**IN THE UNITED STATES PATENT AND TRADEMARK OFFICE**

Patentee:	Kevin L. Parsons, et al.	)
		)
Patent No.:	6,749,317	)
		)
Dated:	June 15, 2004	)
		)
Serial No.:	10/045,231	)
		)
Filed:	November 9, 2001	)
		)
Primary		)
Examiner:	J. Ward	)

**REQUEST FOR CERTIFICATE OF CORRECTION**

Correction to FIG. 2

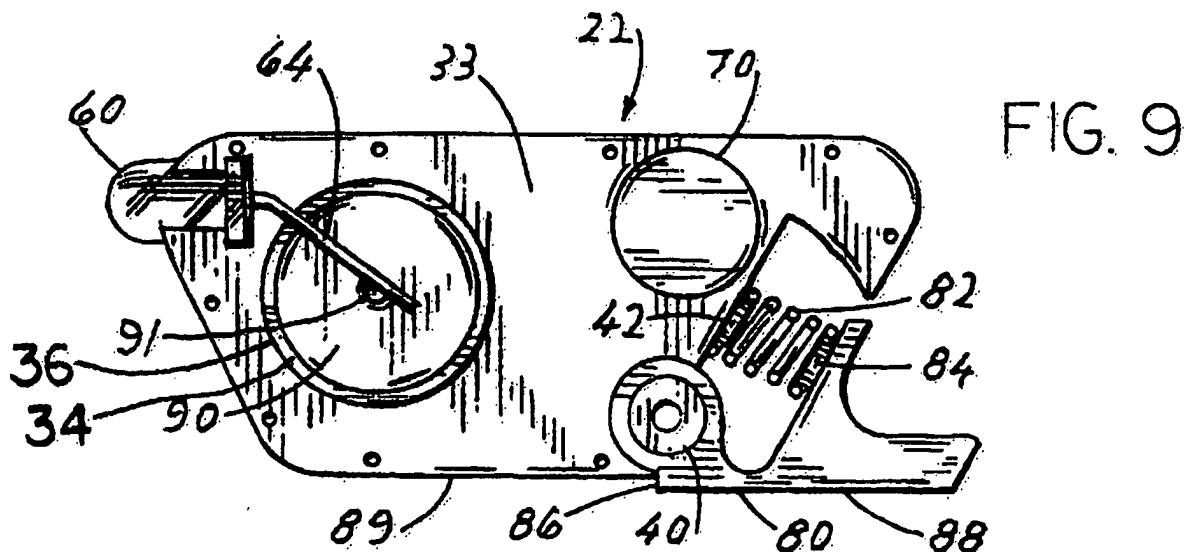
In the drawings, Sheet 1, FIG. 2, the reference numeral "2" should read --12--.

This corrects a typographical error. In the specification, reference numeral 12 refers to "a side cover" while the numeral 2 is not used. As corrected, FIG. 2 should therefore appear as follows:

FIG. 2

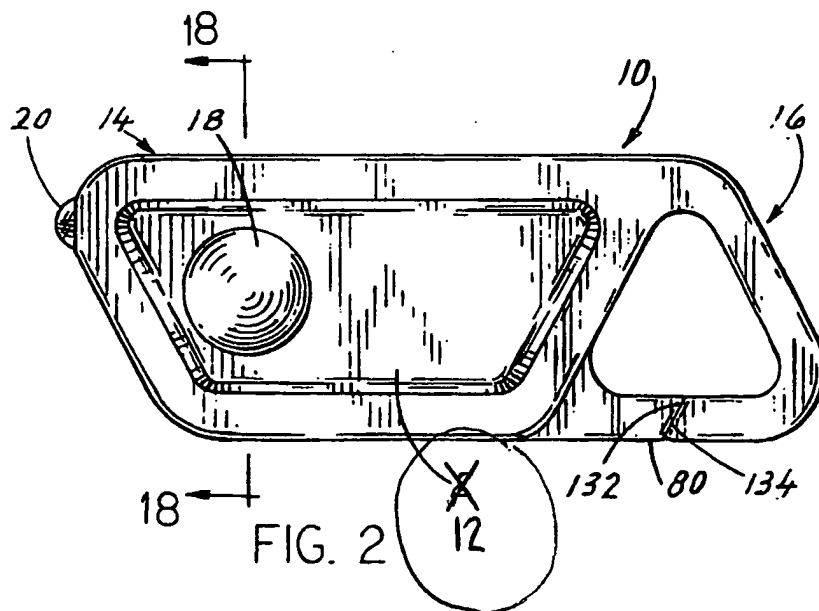
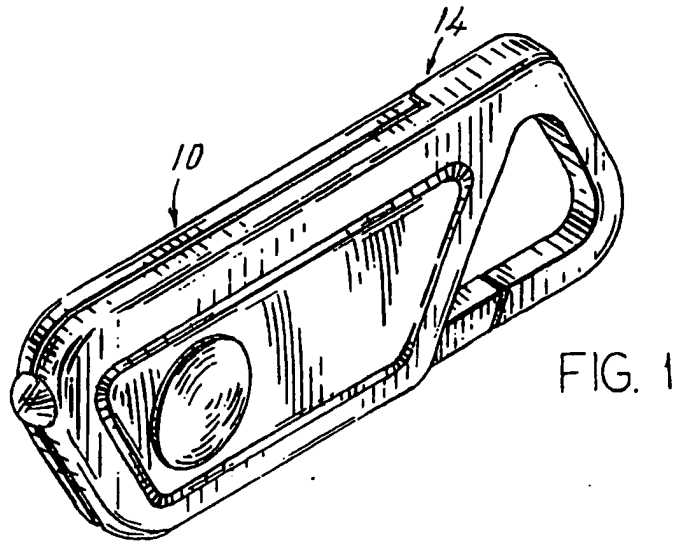
A copy of the drawing sheet showing with the correction to FIG. 2 highlighted is attached hereto and is entitled "Marked-up Copy of Sheet for FIG. 2."

FIG. 9

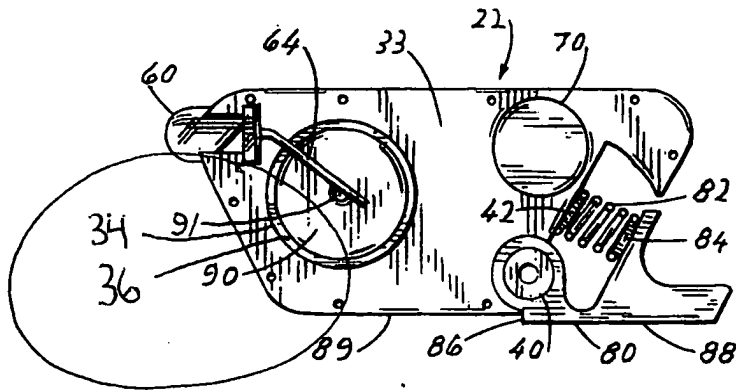
In the drawings, Sheet 3, FIG. 9, the reference numeral 34 and the related lead line should be applied to the counterbore.

In the drawings, Sheet 3, FIG. 9, the reference numeral 36 and related lead line should be applied to the terminus of the counterbore 34.

A portion of the specification that refers to FIG. 9 (see column 9, lines 1-10) identifies a counterbore 34 and a terminus 36. However, the current FIG. 9 does not have these reference numerals or lead lines for them. As corrected, FIG. 9 should therefore appear as follows:

A copy of the drawing sheet showing the corrections to FIG. 9 highlighted is attached hereto and is entitled "Marked-Up Copy of Sheet for FIG. 9."

FIG. 2

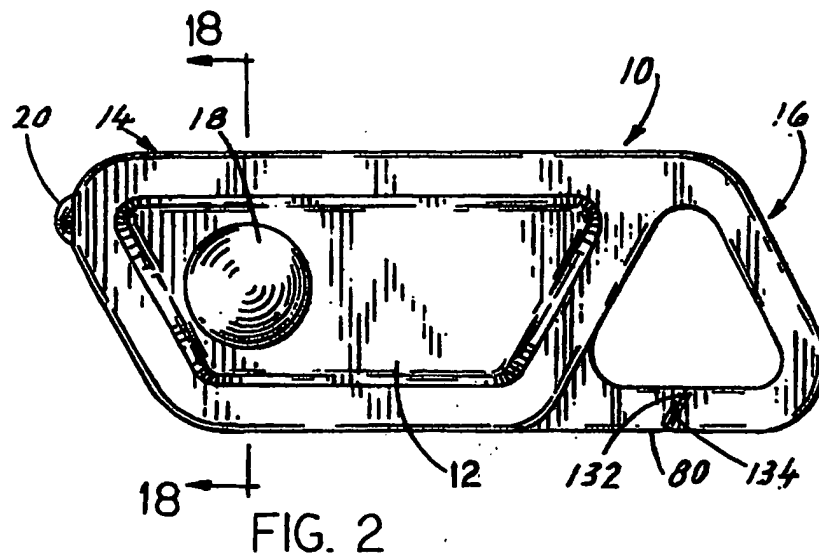
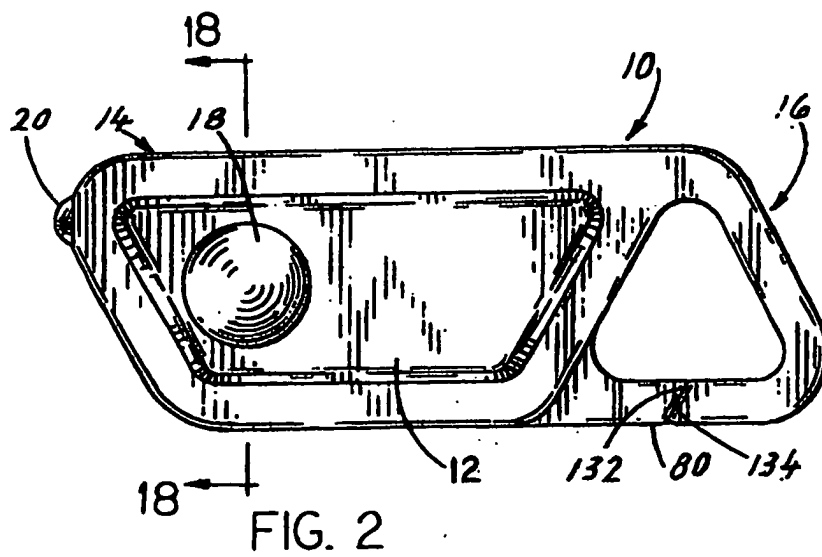
The correction to FIG. 2 is outlined on Form PTO-1050 and the referenced "Replacement Sheet for FIG. 2." Two copies of each document are included herewith.

Delete Figs. 2 and 9 and substitute attached Replacement Sheets for Figs. 2 and 9.

FIG. 9

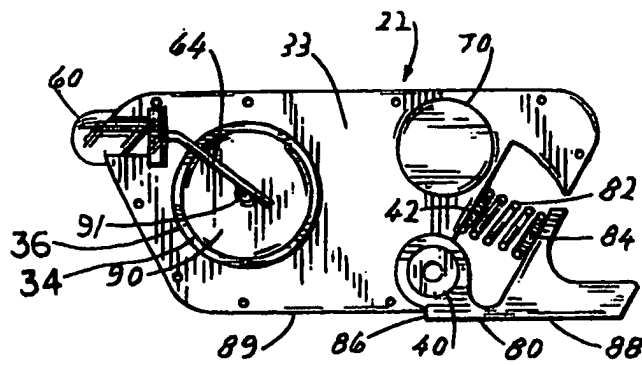
The correction to FIG. 9 is outlined on Form PTO-1050 and the referenced "Replacement Sheet for FIG. 9". Two copies of each document are included herewith.
